# SCE-APH

DESCRIPTION:  
Pull Handle - 0.30 Round - 4.30 in. X 1.30 in. - Aluminum - PARD ID 100962

DRAWN BY: PURTILL		CUSTOMER: SAGINAW CONTROL & ENGINEERING	
DATE: 06/24/13		PART NUMBER: SCE-APH	REV: A
ALUMINUM		CUSTOMER I.D.: SCE2	 Your Enclosure Source®
MATERIAL UNLESS SPECIFIED		SHEET: 1 OF 1

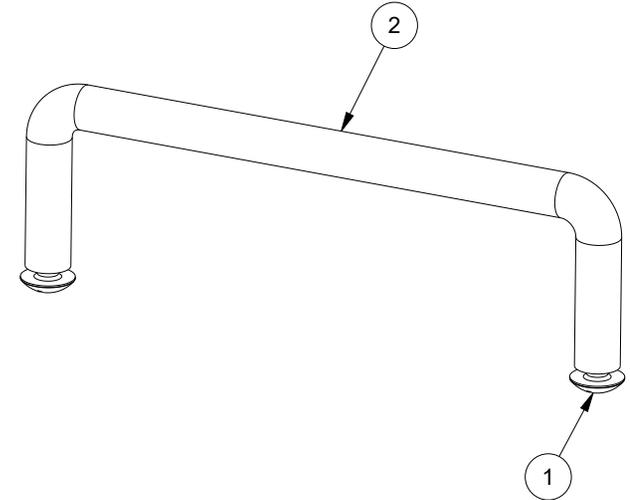
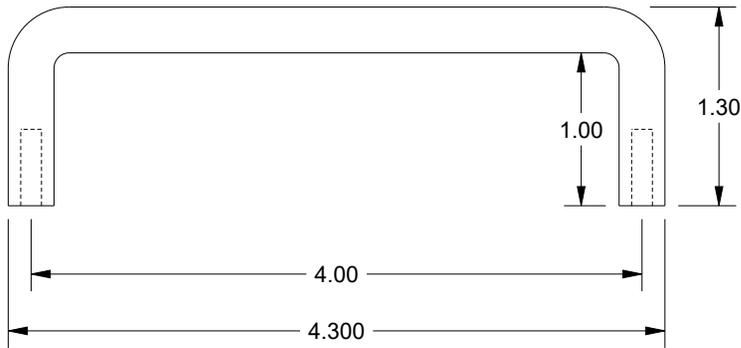
DEP	A	ECR	DESCRIPTION OF CHANGES	DATE
BY	REV.	ECR	Changed Dia. from 0.25 to 0.30, 1.00 was 1.13, 1.30 was 1.38	02/15/18
